Registry No. H11927

Descriptive Report to Accompany Hydrographic Survey H11927

Project OPR-N338-RA-08
Approaches to Warrenton, Oregon
Tongue Pt. to Harrington Pt.
Scale 1:10,000
September 15-23, 2008
NOAA Ship *Rainier* (s221)
Chief of Party: Captain Donald W. Haines, NOAA

Figure 1: H11927 Survey Limits and junction overlaid on (18521)

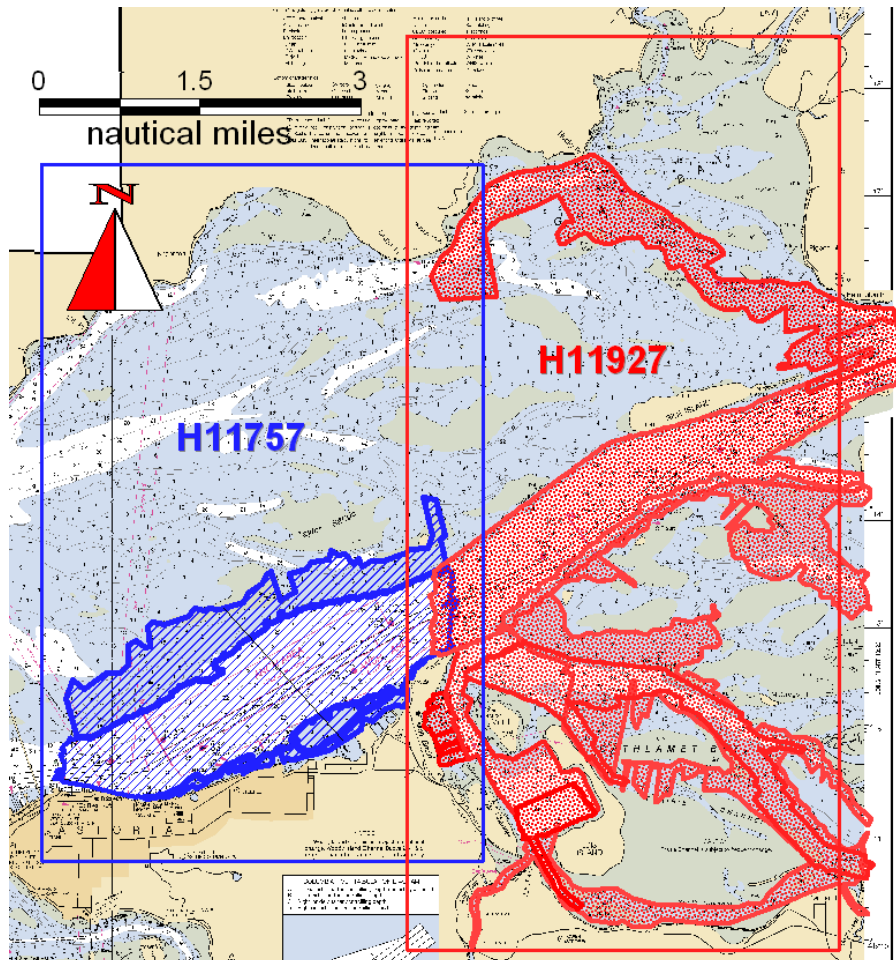
Due to limited time constraints, survey coverage was “blocked off” to maximize coverage of the navigationally significant area of the Columbia River. Limited survey coverage was obtained north of Rice Island, focused on detecting a “buoy run” north from Harrington Pt. to Rocky Pt. (See Figure 1)³

- ² Do not concur, single beam is used as a mainscheme source of hydrography in most of the regions of this survey.
- ³ Due to very sparse coverage portions of single beam data from the buoy run shown in figure 1 were rejected during survey compilation due to inadequate survey coverage.

Figure 13: Charted wing walls not observed (18521, 18523)

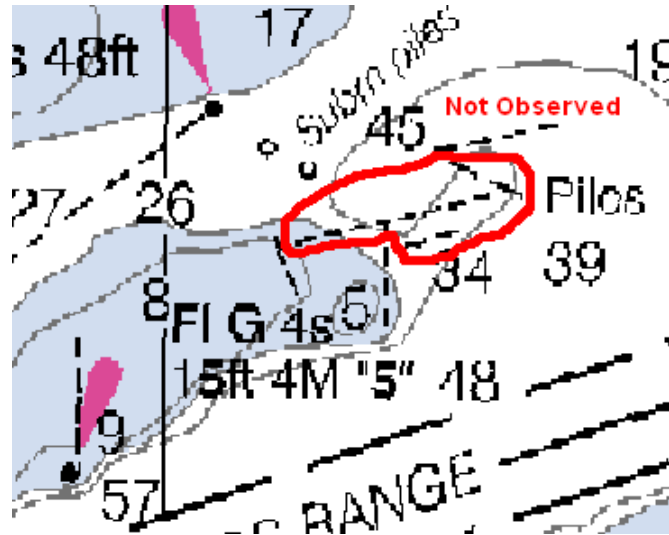
The three charted wing walls, circled in red, south of Harrington Pt. were not detected with VBES, MBES, and SSS searches (See Figure 13). These wing walls were correctly not contained in the original composite source file. The other charted wing walls in the common area are in good condition and are correctly charted. The Hydrographer recommends charting the wing walls as per field verified HOB file. ¹⁷

- ¹² Concur.
- ¹³ Concur.
- ¹⁴ DTON report is appended to this report.
- ¹⁵ Concur.
- ¹⁶ Concur.
- ¹⁷ Concur, the wing wall depicted in figure 13 is not included in H11927CS.000 and has a blue note stating "remove wing wall".

Figure 14: Charted wing walls observed (18521)

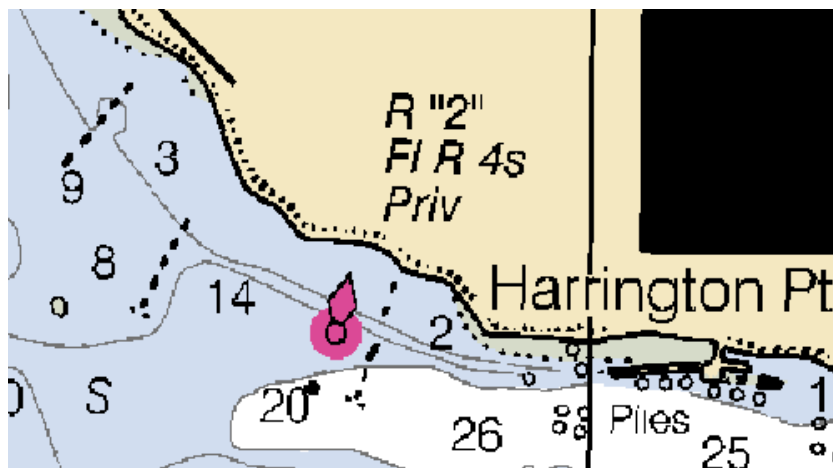
The three charted wing walls west of Harrington Pt. were observed to be correctly charted and in ruined condition except as modified in the Field Verified HOB file (See Figure 14). The Hydrographer recommends retaining these wing walls as charted and modified in the digital data.¹⁸

- ¹⁸ Concur, wing walls depicted in figure 14 are included in H11927CS.000 and attributed as ruined.
- ¹⁹ Concur with clarification, in the positions of the four piles shown in figure 15 four obstructions with category of obstruction of snag/stump, have been added to H11927CS.000. Each obstruction's inform field states "submerged piling".

Figure 15: Charted piles not detected (18521, 18523)

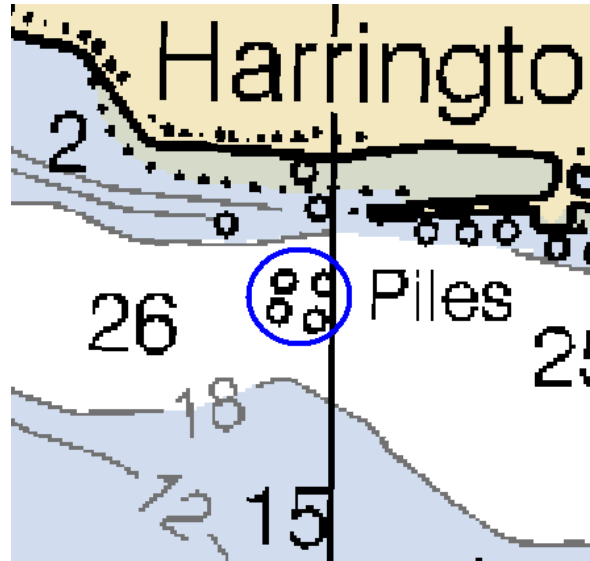
The four charted piles circled in blue, south of Harrington Pt., were not detected (See Figure 15). These piles were investigated visually and using a VBES star pattern (1103-DN267). Full 200% SSS coverage was not obtained in the common area. The Hydrographer recommends retaining the charted piles as “Subm piles”.¹⁹ (18521, 18523)

Figure 16: Charted submerged piles not detected (18521, 18523)

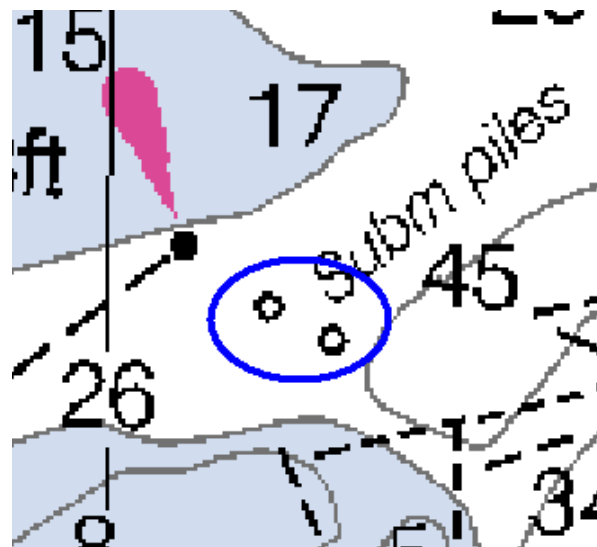
The two charted submerged piles circled in blue, south of Harrington Pt., were not detected (See Figure 16). These piles were investigated visually and using a VBES star pattern (1103-DN267). Full 200% SSS coverage was obtained in the common area further disproving these piles. The Hydrographer recommends removing the charted submerged piles and charting common area as per digital data.²⁰ (18521, 18523)

- ²⁰ Concur, a blue note is included in H11927CS.000 to remove the submerged piles.
- ²¹ Concur with clarification, in the positions of the three piles shown in figure 17 three obstructions with category of obstruction of snag/stump, have been added to H11927CS.000. Each obstruction's inform field states "submerged piling".

Figure 17: Charted piles not detected (18521)

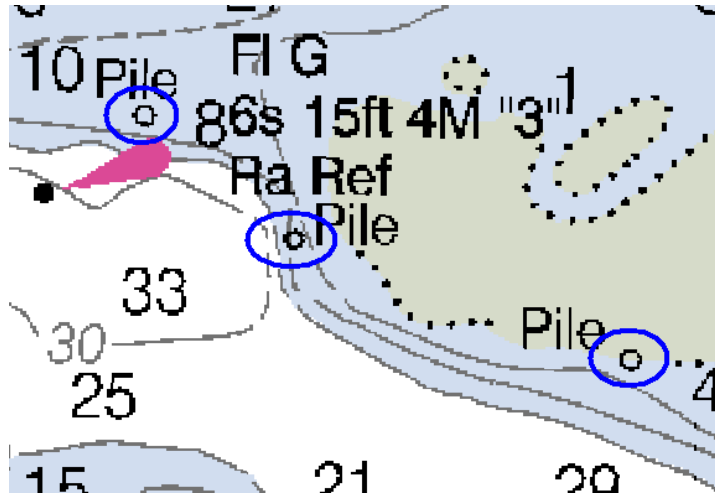
The three charted piles, circled in blue, in the vicinity of the Green “3” Light in Cathlamet Bay North Channel were not detected during shoreline. (See Figure 17) These piles were investigated visually and using a VBES star pattern (1103-DN264). Full 200% SSS coverage was not obtained in the common area. The Hydrographer recommends retaining these piles as “Subm piles”.²¹ (18521)

Figure 18: AWOIS item 53698 (18521)

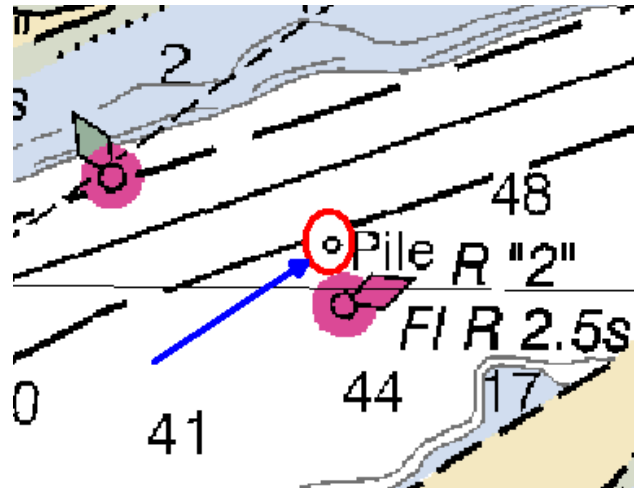
Two (2) AWOIS items fall within the survey limits of H11927. AWOIS item 53698 located at approximate position 46°15'N, 123°41'W was not detected. (See Figure 18) This item was assigned for full investigation of a charted pile on the edge of the channel of Miller Sands Range. 200% Side scan sonar was achieved in the entirety of the search radius and no indication of the piling was found. The Hydrographer recommends removing the charted pile from the chart.²⁵

- ²³ Concur.
- ²⁴ DTON report is appended to this report.
- ²⁵ Concur. Blue note has been added to remove the pile.
- ²⁶ Concur.
- ²⁷ Per end note 28 no survey feature report is appended to this report. Description of the two AWOIS items within section D.1.c is adequate.

Figure 21: Southernmost boat ramp in Mott Basin (18521); left- SSS mosaic; right- associated charted obstruction

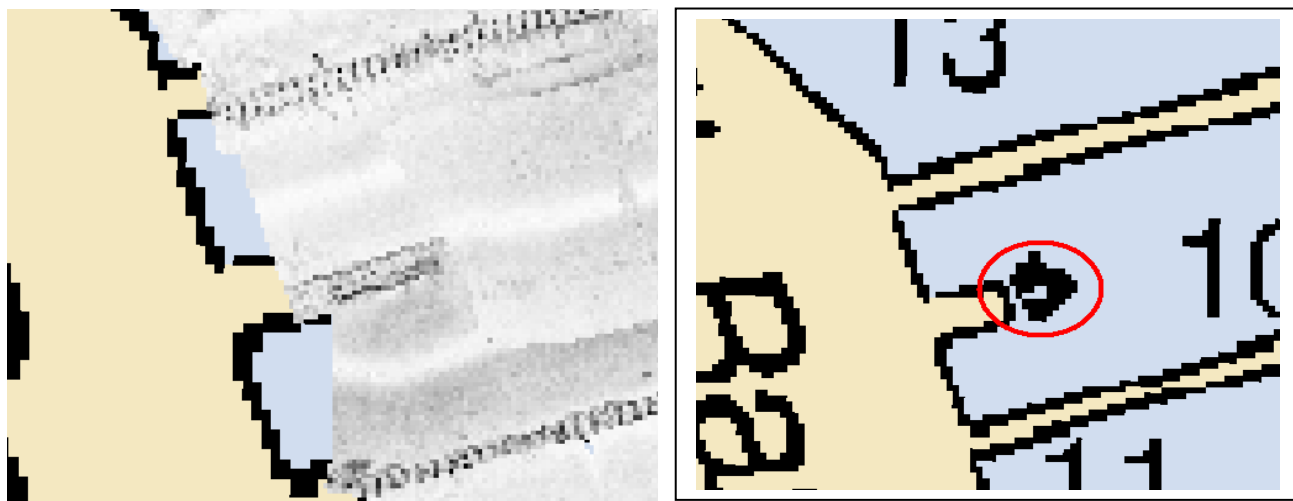
A charted obstruction attached to the end of the southernmost boat ramp in Mott Basin was observed to be the extension of the ramp below the waterline as is illustrated with the SSS mosaic (See Figure 21). The Hydrographer recommends removing the charted obstruction and charting as per digital notebook data depicting the submerged portion of the boat ramp (18521).²⁹

- ²⁸ Concur.
- ²⁹ Concur with clarification, surveyed extent of boat ramp included in H11927CS.000 and a blue note has been added to remove the obstruction.

Figure 22: Rotating Railroad Bridge; Camera angle view is from South to North (18521)

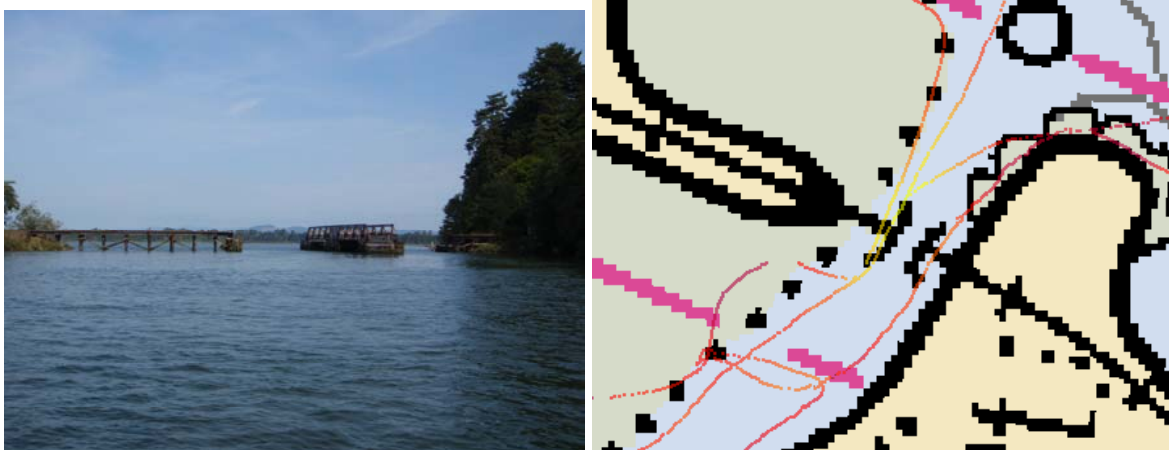
There are three overhead features within the limits of survey H11927. A charted railroad bridge located at John Day Pt., had an observed overhead clearance of approximately 2.5 meters when closed. (See Figure 22) The charted railroad bridge position appears to be correctly charted and in very good condition. When the bridge is open, as illustrated in Figure 22, one could navigate on either side of the bridge. The Hydrographer recommends correcting the charted symbol in order to accurately depict a rotating bridge feature.³⁵ (18521)

³⁵ Concur, added blue note to H11927CS.000.
